January 20, 2017
BOARD OF COUNTY COMMISSIONERS
ORANGE COUNTY, FLORIDA
Addendum No. 3 / IFB Y17-729-CC
East Orange Regional Park

1. Revision: The following “**East Orange County Park Multipurpose Field**” drawings have been revised and are attached:

OVERALL SITE DEVELOPMENT PLAN
EAST ORANGE COUNTY PARK MULTI-PURPOSE FIELDS
ORANGE COUNTY PARKS + RECREATION
 ORANGE COUNTY, FL

OVERALL SITE DEVELOPMENT PLAN
 SCALE: 1" = 60'

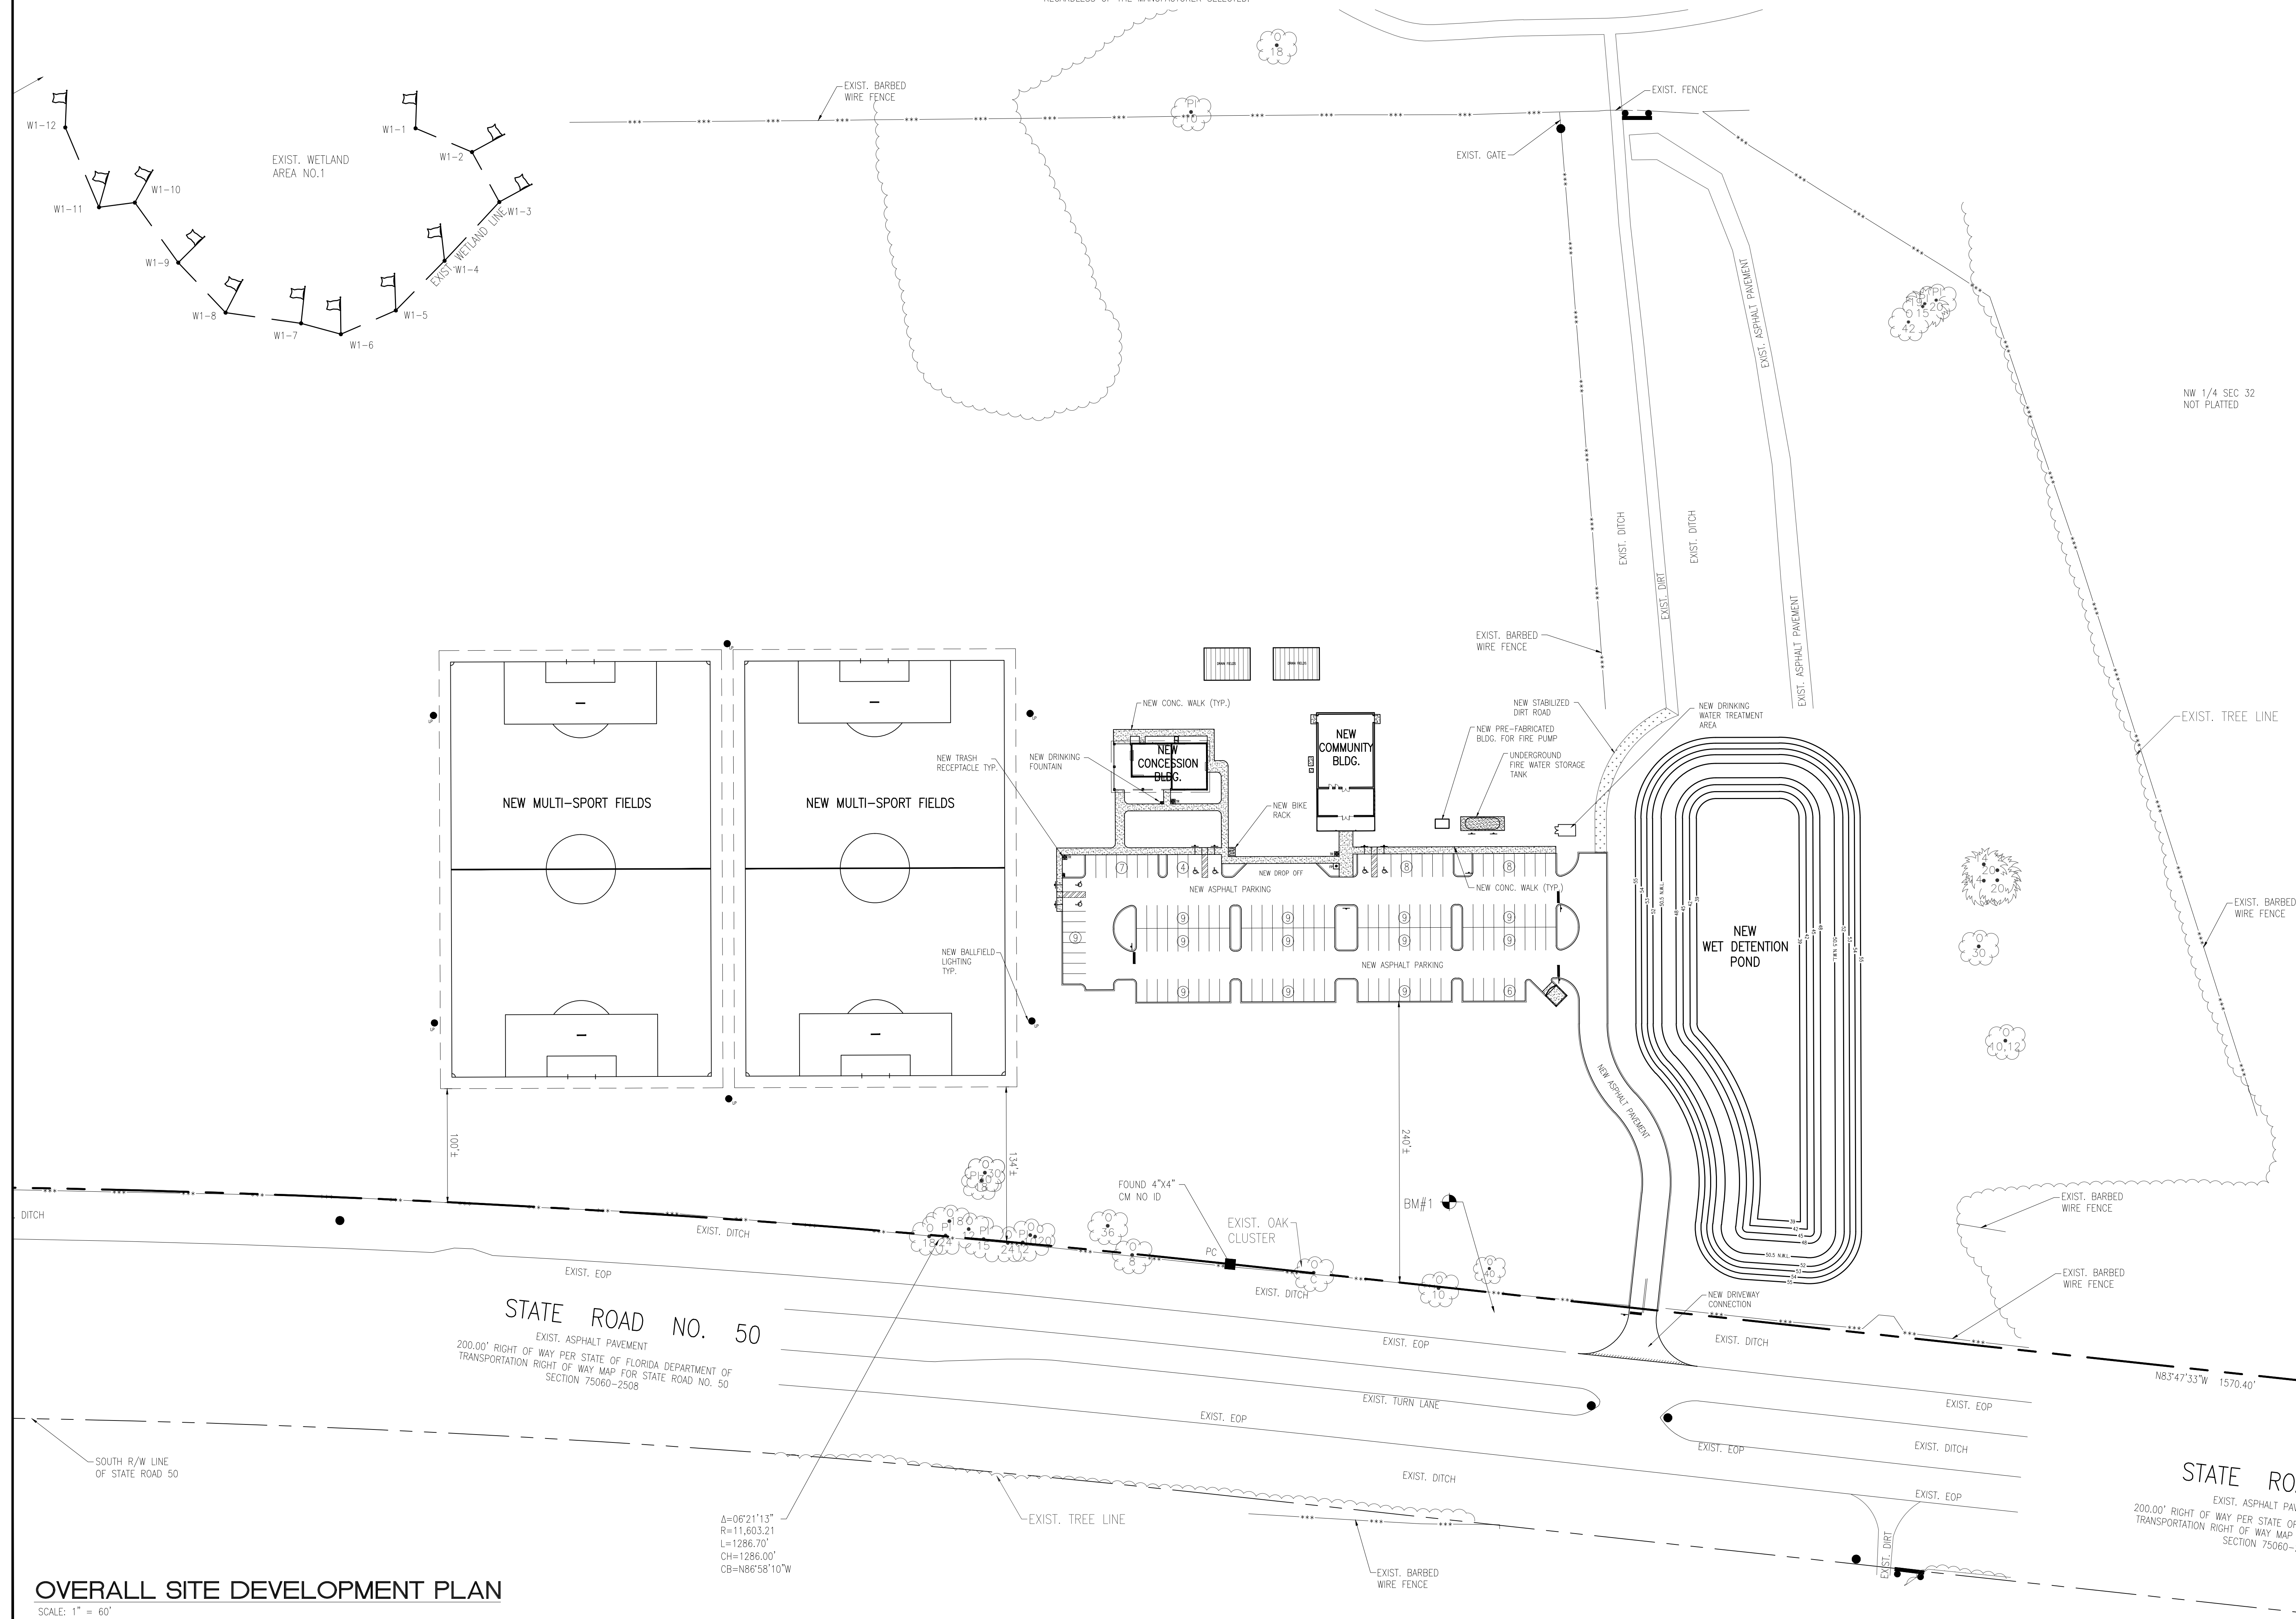
Answer: Site electrical and lighting plans are included in this addendum.
2. **Question (applies to the site drawings titled “East Orange County Park Multipurpose Field”)**: On the Civil Sheets it does not show any grass parking locations or details, but on A102 of the Recreation Building and sheet C100 of the Concession/Storage/Restroom Building it shows a grass parking area. Are we responsible for the Grass Parking Lot? If so please provide plans/details.

Answer: Please use sheet C100 in civil set as the development plan for the project. There are only 2-lit ball fields and no provision for grass parking.
